FROM: Rebecca Ballo  
Historic Preservation Section Maryland-National Capital Park & Planning Commission  
Historic Area Work Permit #1054192 - Revisions to retaining wall treatments associated

SUBJECT: with shared use path.

**Case Number:** 1054192

**PROPOSAL:** Revisions to retaining wall treatments associated with the previously approved shared-use path.

SECTION A-A  
SCALE: 3/4" = 1'-0"

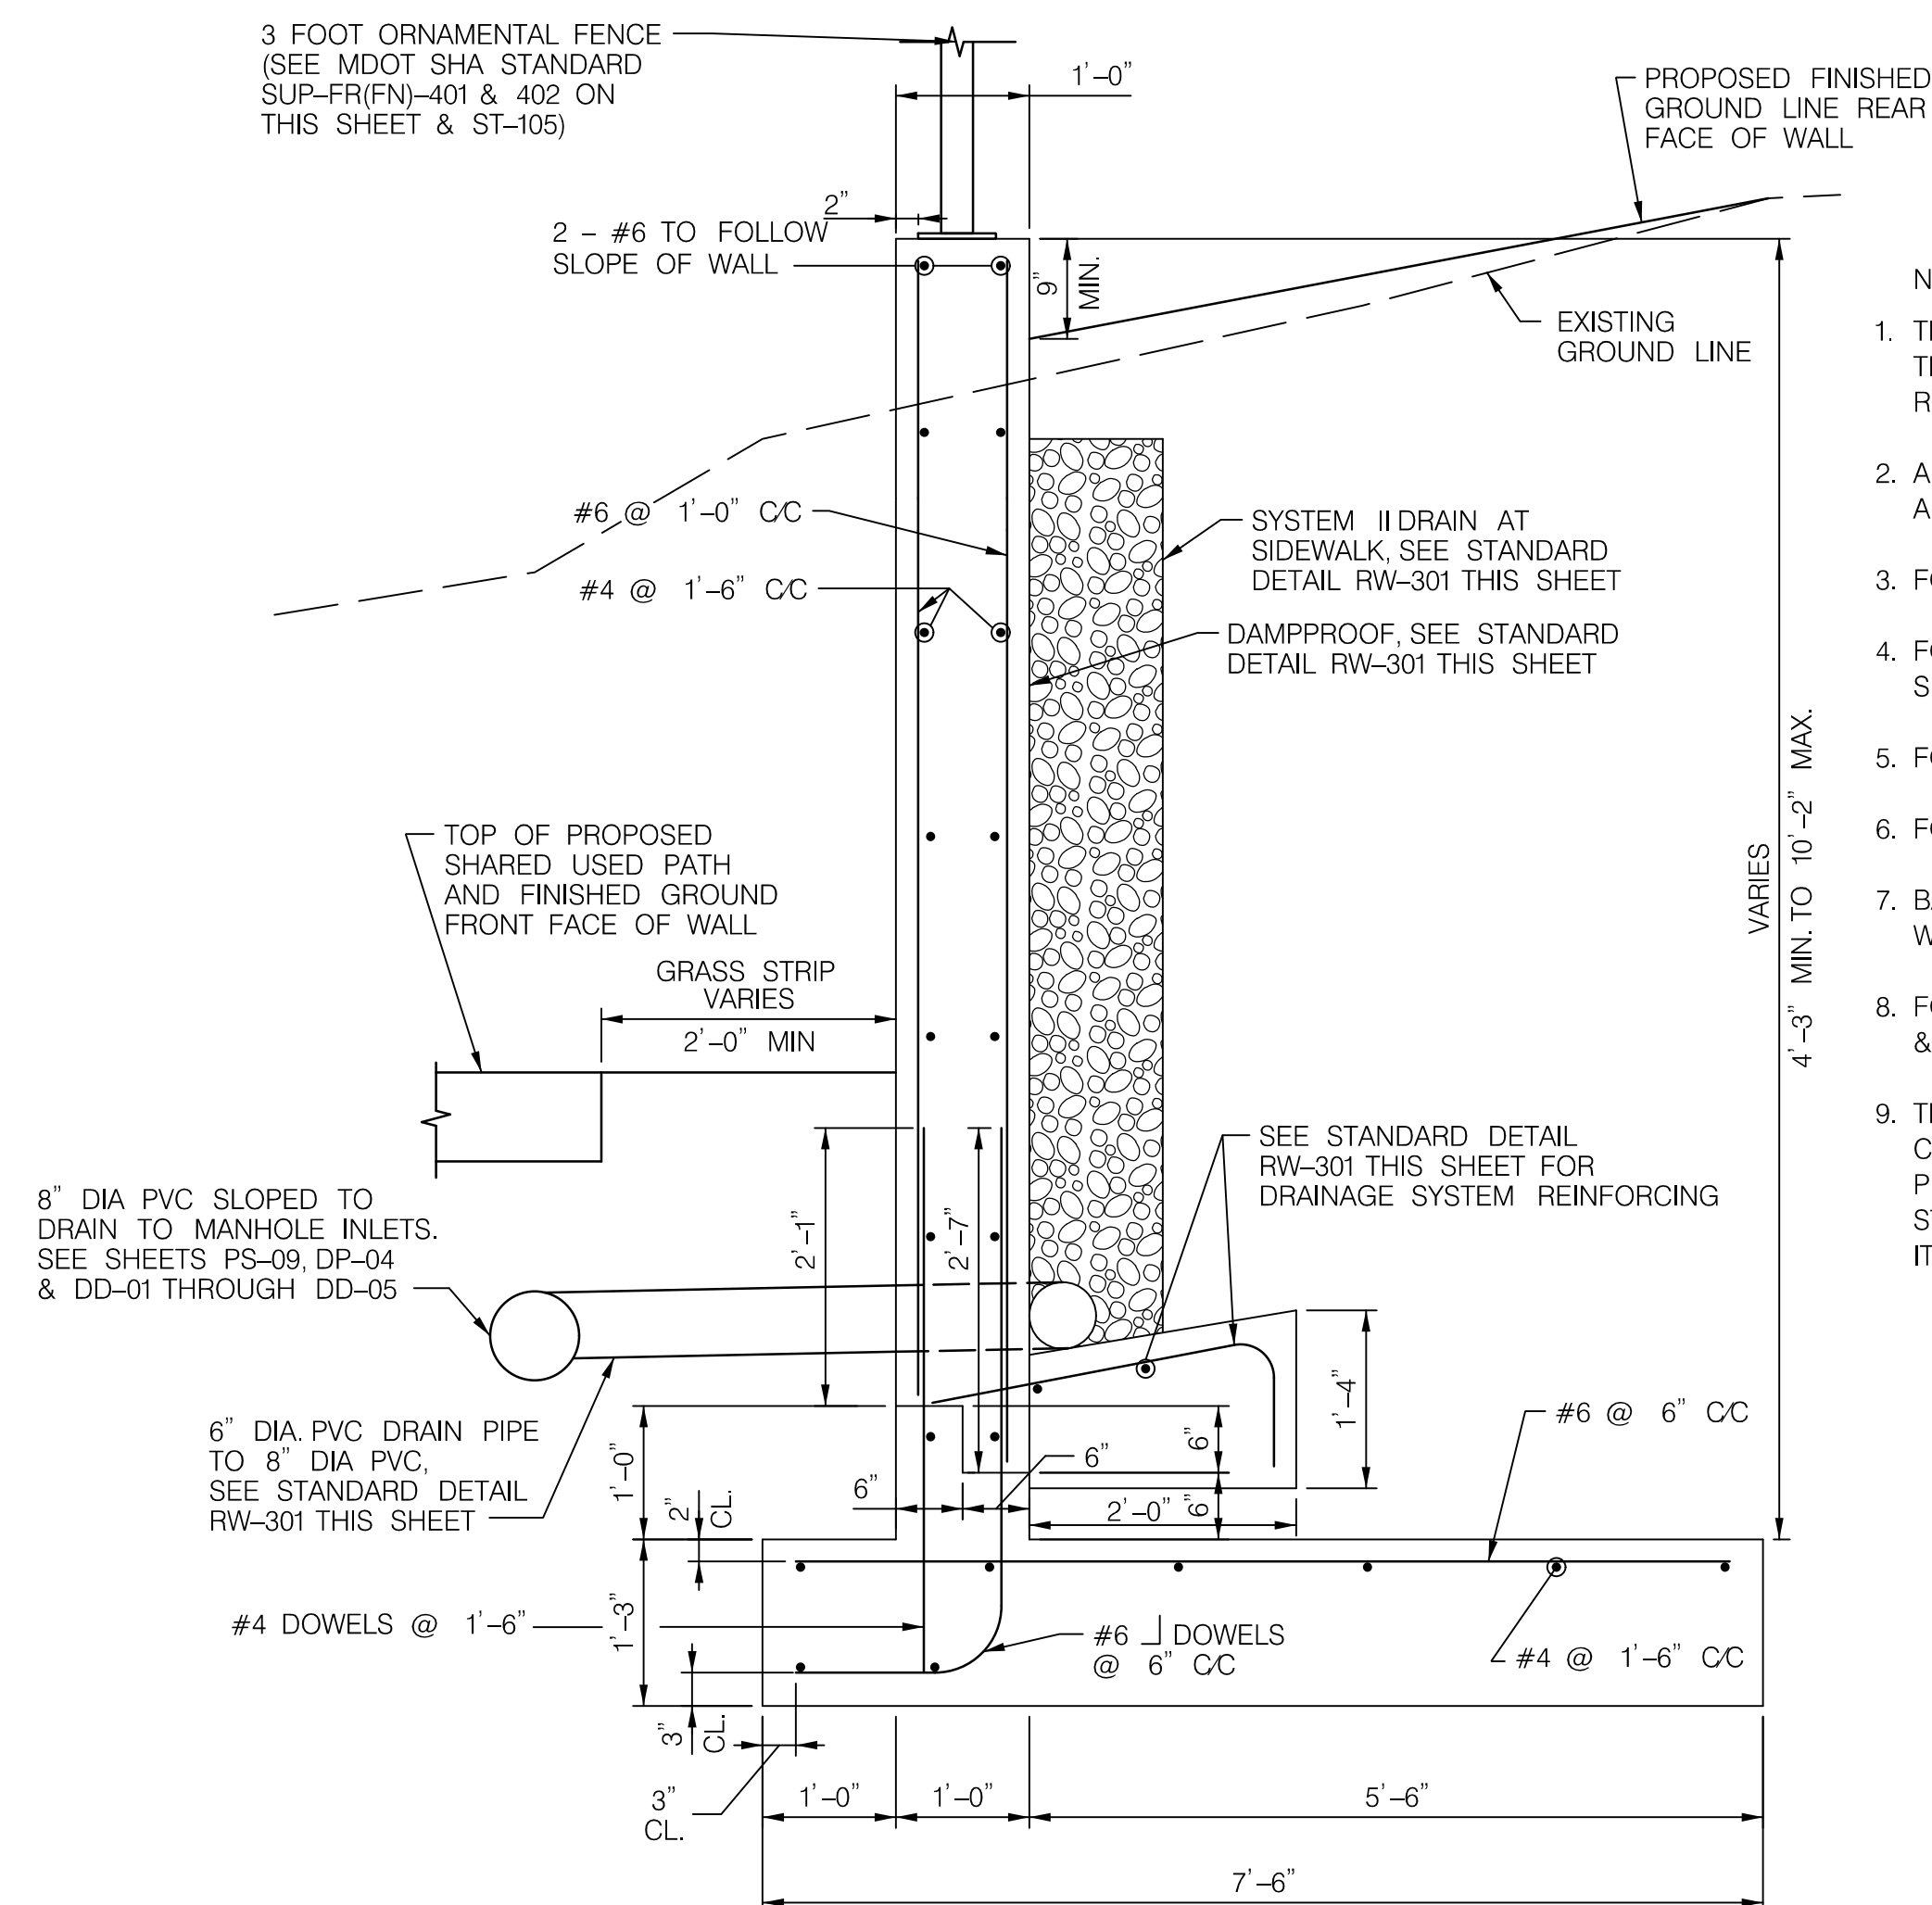
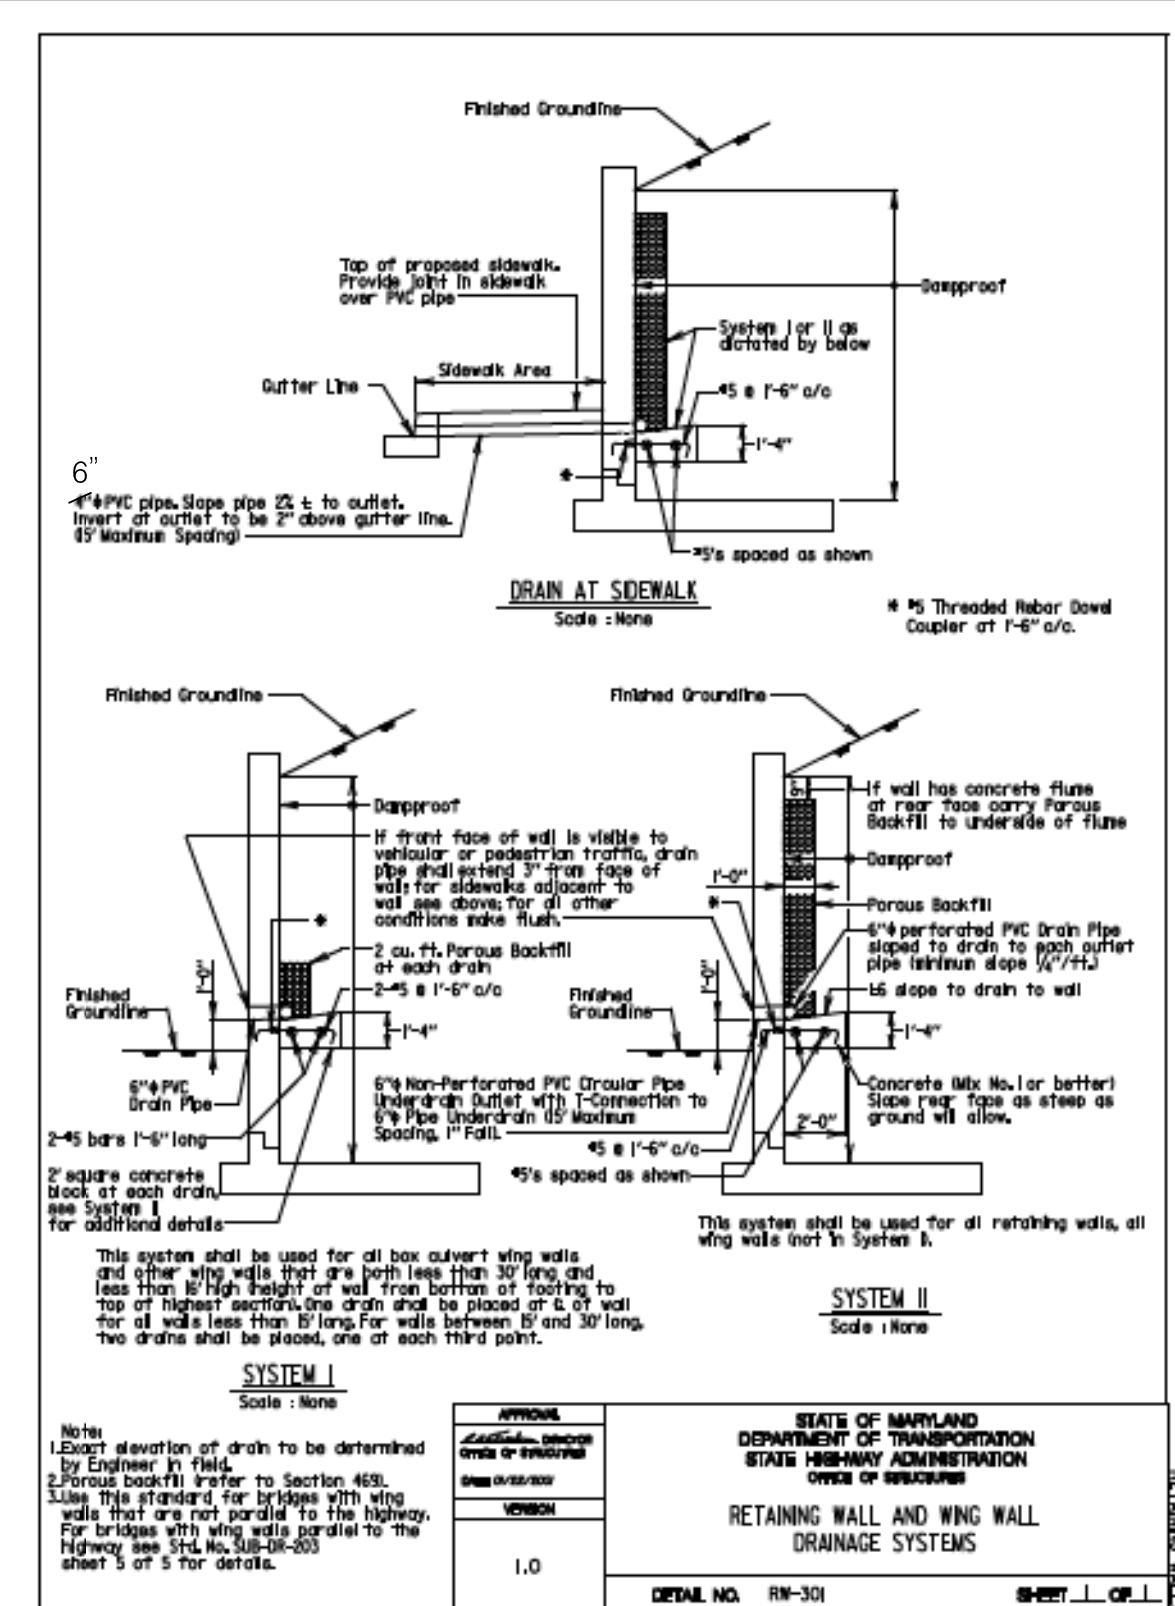
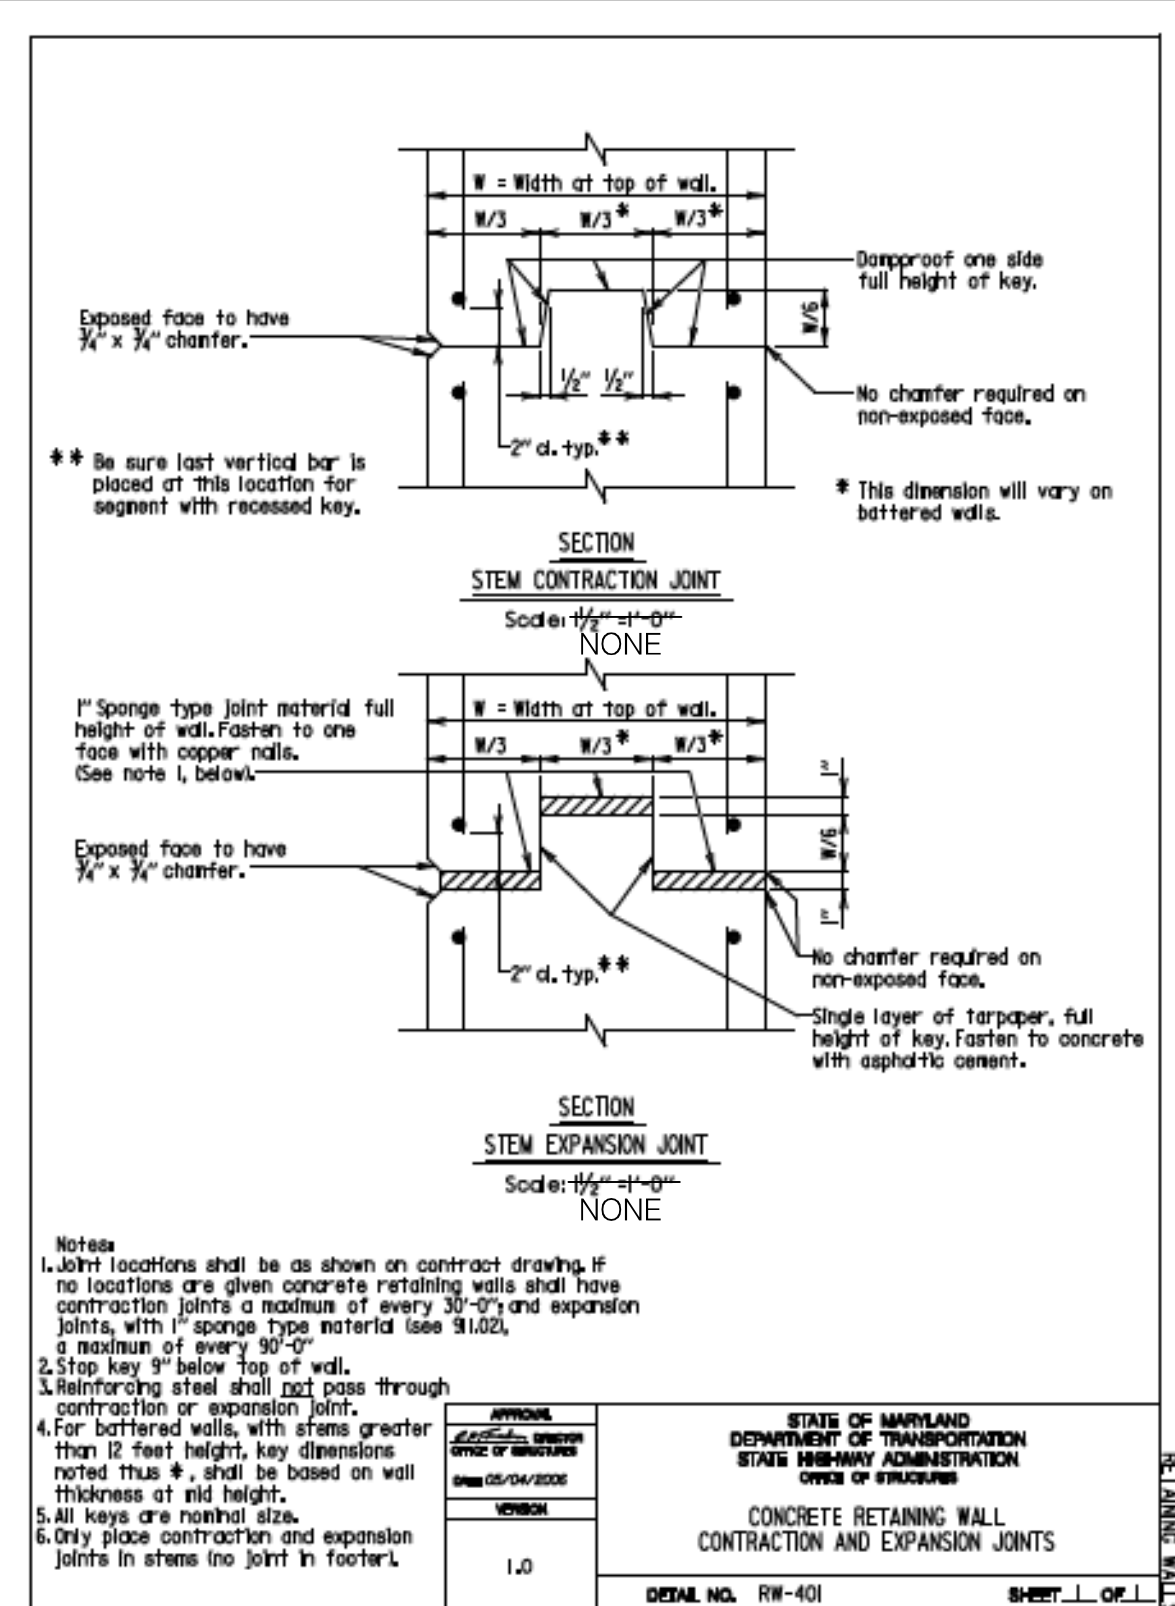
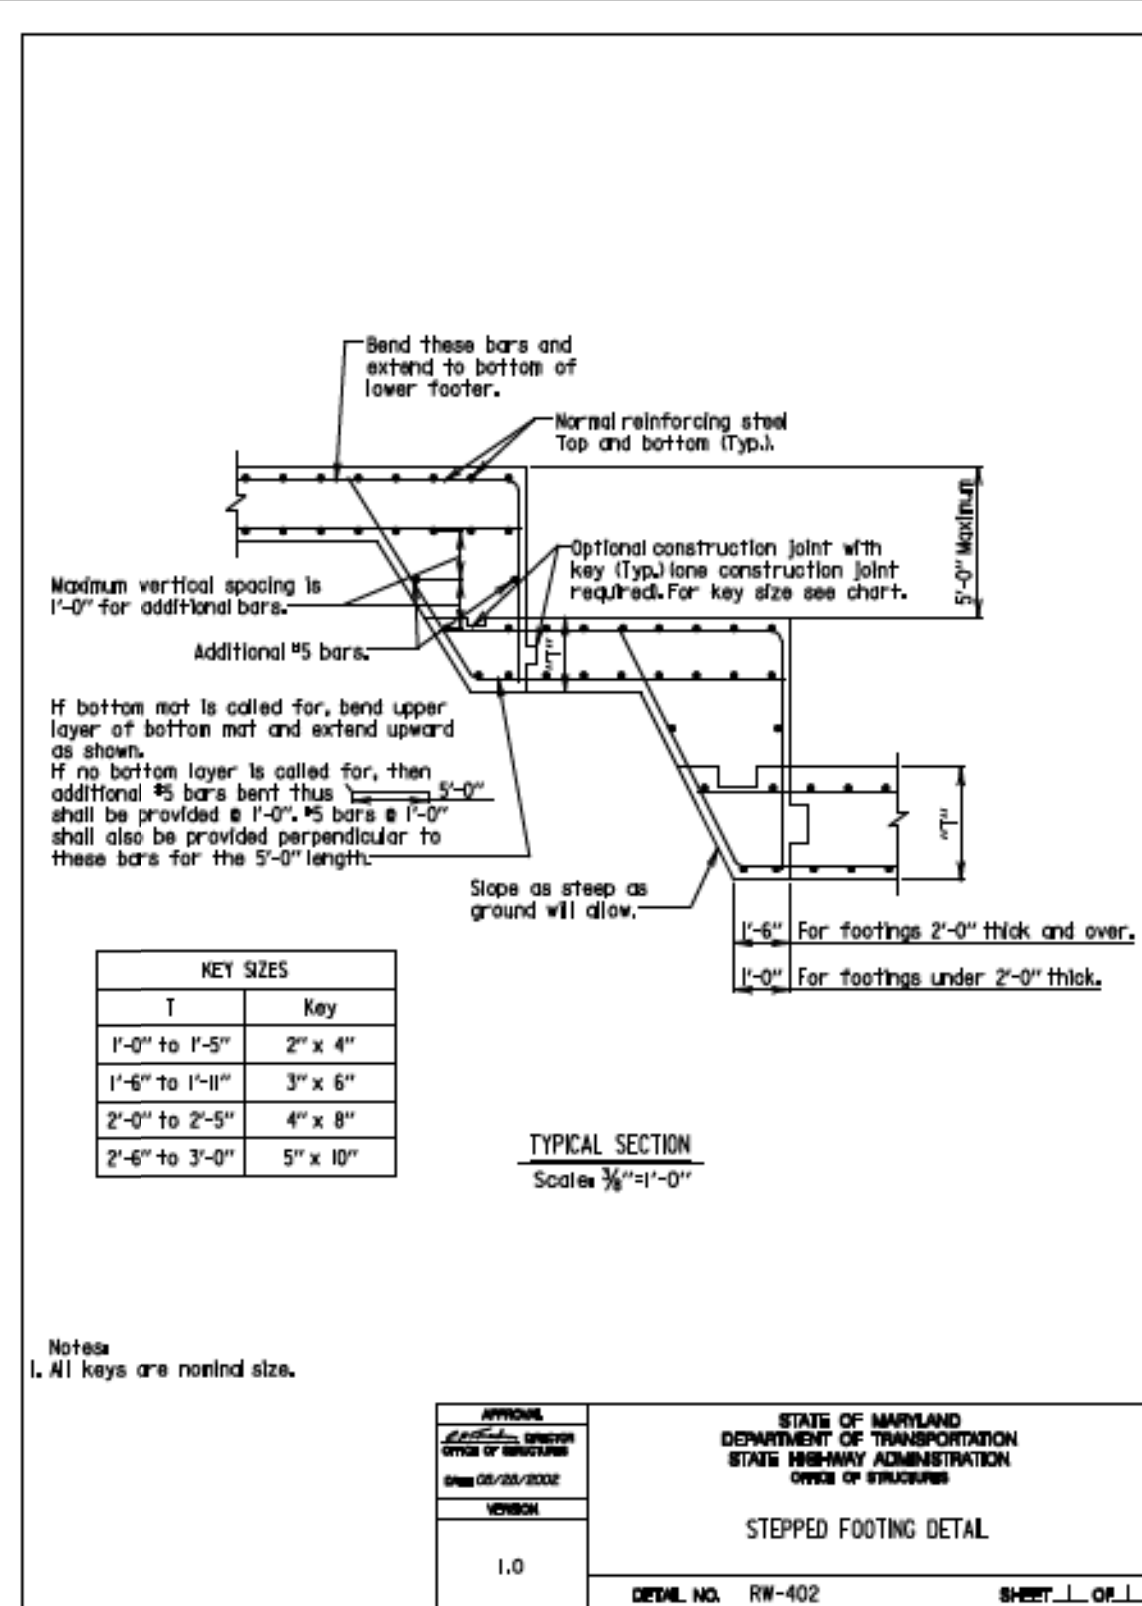
The Stone Facing is approved, NOT the white textured block face.
